APPLICATION NO.	FILING DATE	FIRST NAMED INVENTOR	ATTORNEY DOCKET NO.	CONFIRMATION NO.
10/661,195	09/12/2003	Steven G. Goebel	8540G-000150	7227
27572	7590	12/14/2004	EXAMINER	
HARNESS, DICKEY & PIERCE, P.L.C. P.O. BOX 828 BLOOMFIELD HILLS, MI 48303			AUSTIN, MELISSA J	
			ART UNIT	PAPER NUMBER
			1745

Office Action Summary	Application No. 10/661,195	Applicant(s) GOEBEL, STEVEN G.	
	Examiner Melissa Austin	Art Unit 1745

DETAILED ACTION

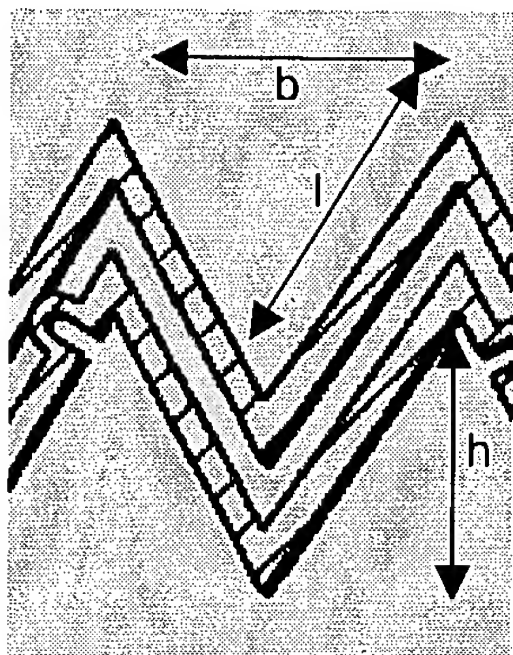
seen in Figure 3, the corrugations (60a, 60b) form a plurality of flow channels for distribution of the reactant gases, fuel and oxidant, to the anode and cathode electrodes, respectively. The corrugations are laterally centered at a distance from each other to form coolant flow channels. The surface area of the coolant flow channels is greater than the surface area of either reactant flow field (see sample calculation below), and the height of the coolant flow channels is substantially the same as the height of either reactant flow field. (Col. 2, ll. 12-62; Col. 3, ll. 52-63)

Considering as an example one pass of a straight channeled flow channel, as illustrated above, where d is the distance between the corrugations and w is the width of the flow channel:

Surface area of reactant flow field: $A_{s,r} = 2wl = 2w \sqrt{h^2 + (0.5b)^2}$

Surface area of coolant flow field: $A_{s,c} = 4wl = 4w \sqrt{h^2 + (0.5b)^2}$

$$A_{s,c} > A_{s,r}$$
